Item No. 8.1.1
Design Review Committee
November 10, 2016

SUBJECT: Case 20806: Substantive Site Plan Approval – Spring Garden Road/Doyle Street Lands, Halifax

Application by Westwood Developments Limited

ATTACHMENT E- SITE PLAN APPROVAL_VARIANCES

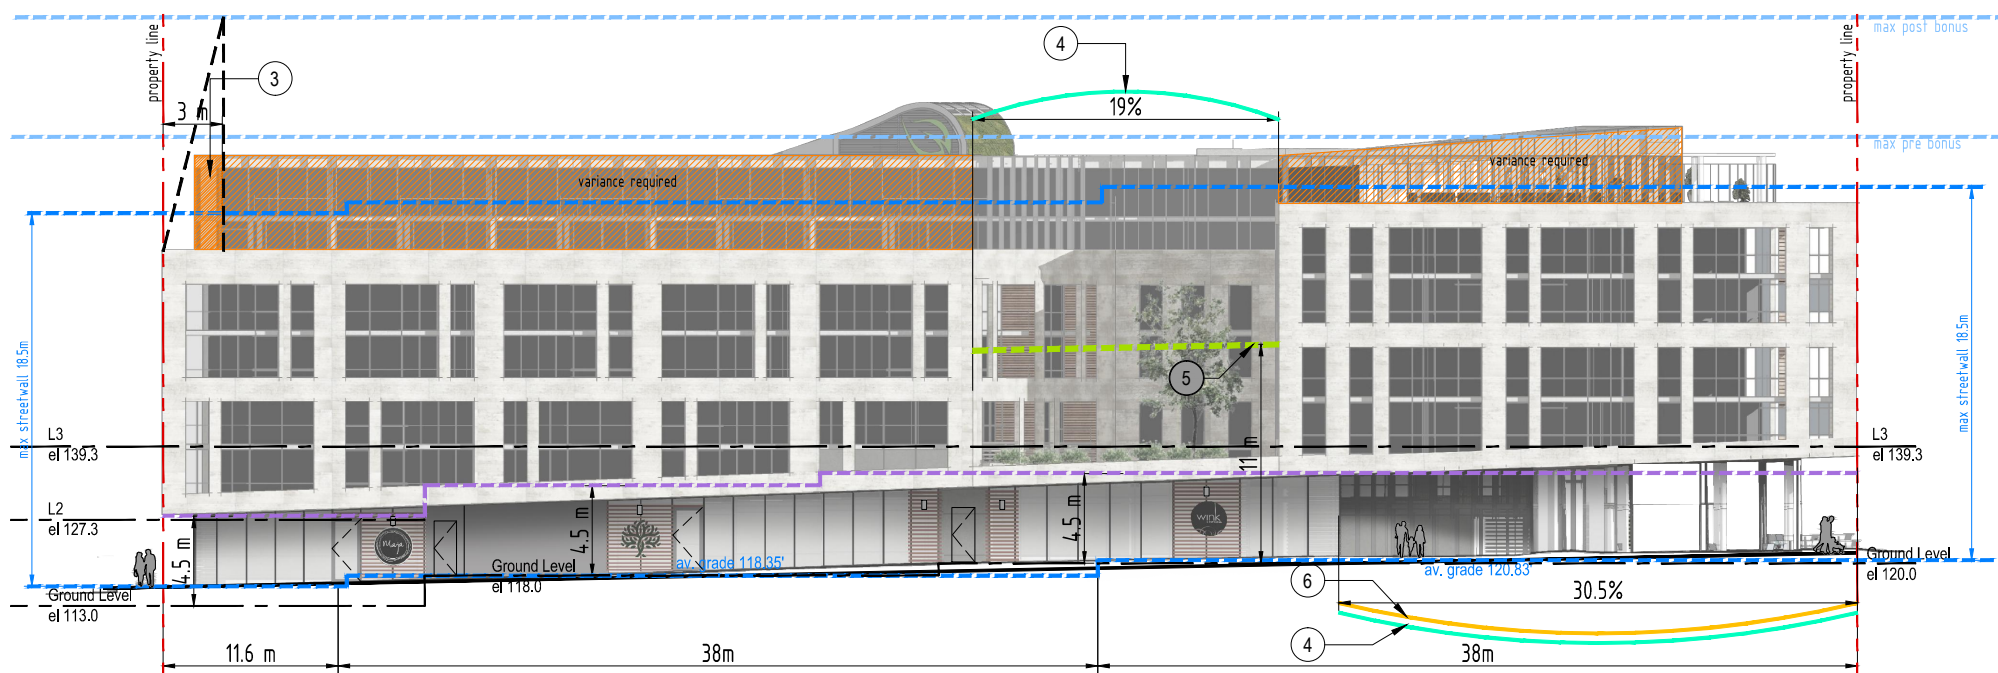
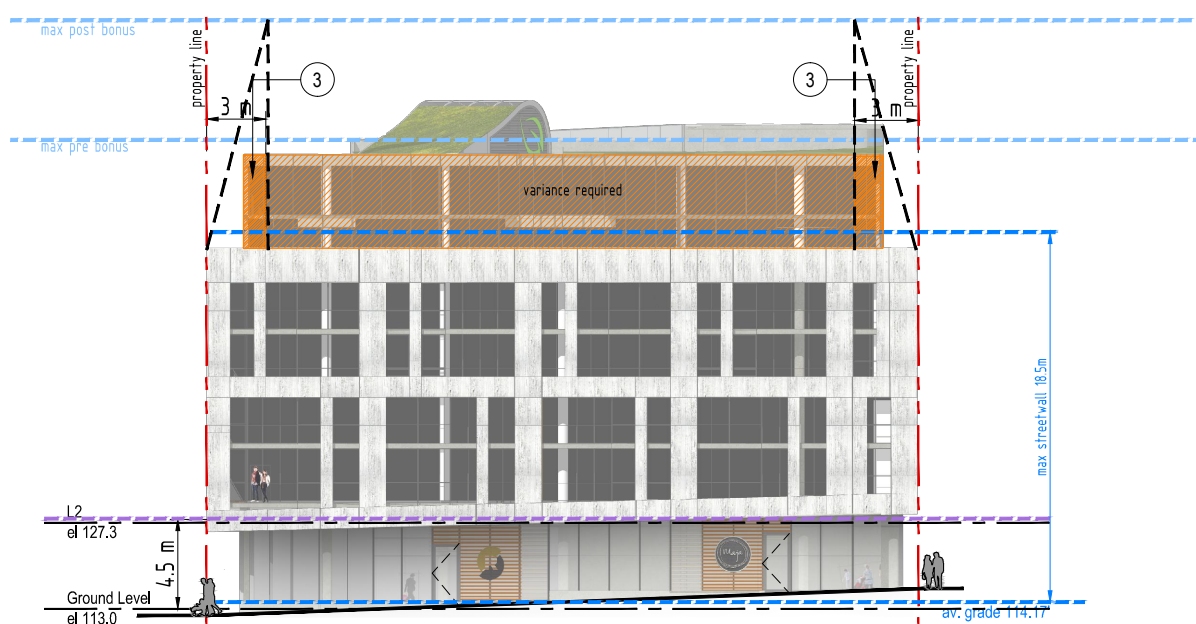
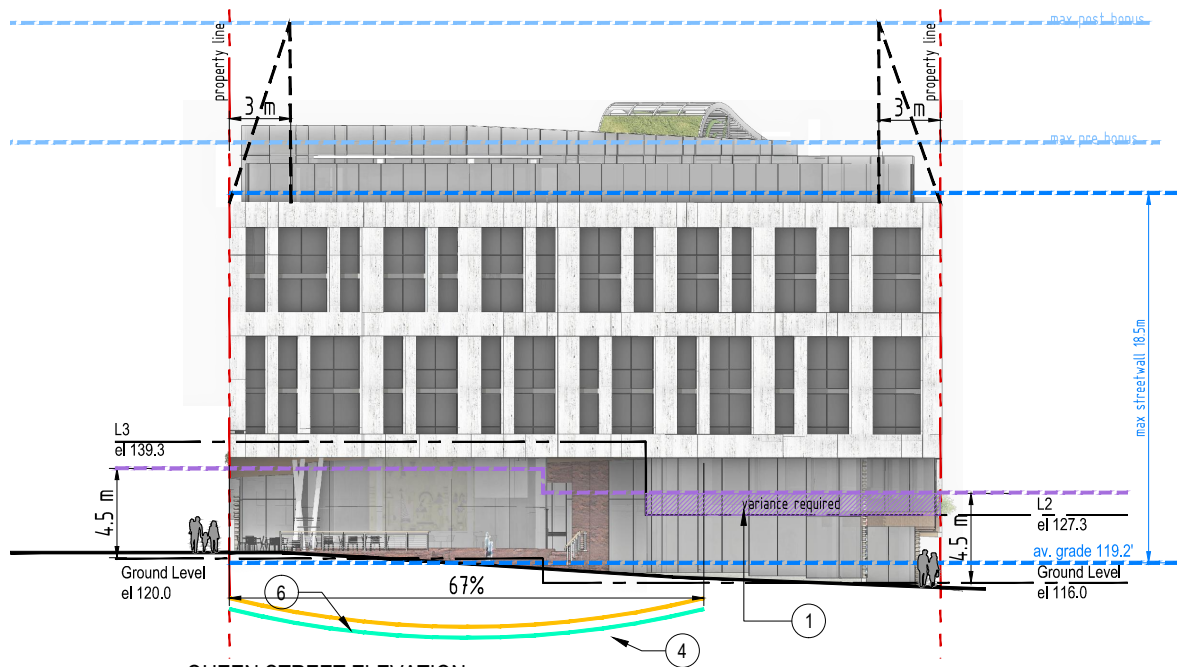
Response: Staff advise that the variance request can be considered under clauses a. and b. of section 3.6.3 of the Design Manual. In this case, while the maximum streetwall height for both Spring Garden Road and Queen Street is the exact same under Map 7 (i.e. 18.5m), sloping conditions on the site lead to differing streetwall heights from a pure elevation stand point. It therefore becomes necessary to ensure a proper transition at the intersection of these two streets. It is also important to note that section 3.1.3 of the Design Manual indicates that streetwall height should generally be no greater than a height proportional (1:1) to the width of the street as measured from building face to building face. In the case of the 38 m portion of Spring Garden Road for which the variance is being sought, the proposed streetwall faces the Halifax Central Library which is setback at a considerable distance from its respective Spring Garden Road streetline. This circumstance would tend to favour a higher streetwall to ensure a comfortable human-scaled street enclosure. Finally, as the applicant has stated in its submission, the presence of a plaza in front of the Central Library also favours a higher streetwall on the Doyle block building to create a strong edge to this important public open space. Accordingly, staff recommend approval of the requested variance.

Response: Staff agrees that it is important to clearly express a building top, especially along such prominent street frontages as Spring Garden Road and Brunswick Street and from the vantage point of Citadel Hill. Staff also agrees with the applicant that the presence of Viewplane #8 has the effect of pushing down the maximum permitted height by approximately two storeys, which results in a building top that is only one to two storeys taller than the maximum streetwall height. This leaves limited opportunities to clearly express a building top when the required upper storey streetwall setback is taken into consideration. Only two options seem available to make the top of the building more visible from surrounding streets, i.e. the variance option presented by the applicant, or a reduction in the overall streetwall height. However, as already discussed under Part B of this Attachment, the particular circumstances along Spring Garden Road all favour a high streetwall, these include: (1) the width of the street as measured from building face to building face; (2) the considerable setback distance of the Halifax Central Library from its respective Spring Garden Road streetline; and (3) the presence of a large plaza in front of the Central Library. Considering the options available to the applicant, the requested variances to the upper storey streetwall setback are reasonable and staff advise that they are enabled under section 3.6.5.

Response: Staff advise that all four variance requests can be considered under clauses a. and b. of section 3.6.4 of the Design Manual. Staff is of the opinion that the rotunda, covered plaza, and covered entrance do bring a unique focus to the Queen Street/Doyle Street corner. The resulting gap has a clear purpose, is well-designed, and will likely make a positive contribution to the streetscape. It is important to note, however, that this design treatment would not be appropriate for all locations. It is also important to note that the applicant will not be benefitting financially from this design treatment, as potentially valuable leasable floor space will be lost to accomplish the unique feature.

Response: Staff advises that both variance requests can be considered under clauses a. and d. of section 3.6.3 of the Design Manual. The applicant has made a case that the upper floor terraces can be considered as landmark building elements, especially on a full block re-development. The case is even stronger for the Spring Garden Road frontage of this block, which is identified as a Prominent Civic/Cultural Frontage. Staff is of the opinion that the upper floor terraces are not appropriate for all locations. For example, they would be less appropriate along Spring Garden Road, from Queen Street to South Park Street. However, in this specific block, which is part of the “monumental” district reference under clause f. of section 2.3 of the Design Manual, they are entirely appropriate and in keeping with the ample display of open space found around the Halifax Central Library, the former Spring Garden Road Memorial Library building, and the generous landscaped setbacks of both the Old Courthouse and Dalhousie University’s Ralph M. Medjuck Building. Therefore, staff recommend approval of this variance request.

Response: Staff advises that both variances requests can be considered under clause a. of section 3.6.1 of the Design Manual. The applicant has made a case that the rotunda anchored by a covered plaza meets the intent of clause b. of section 3.2.2 of the Design Manual, regarding building orientation and placement, and staff does not object to such an interpretation. Accordingly, staff recommend approval of this variance request.
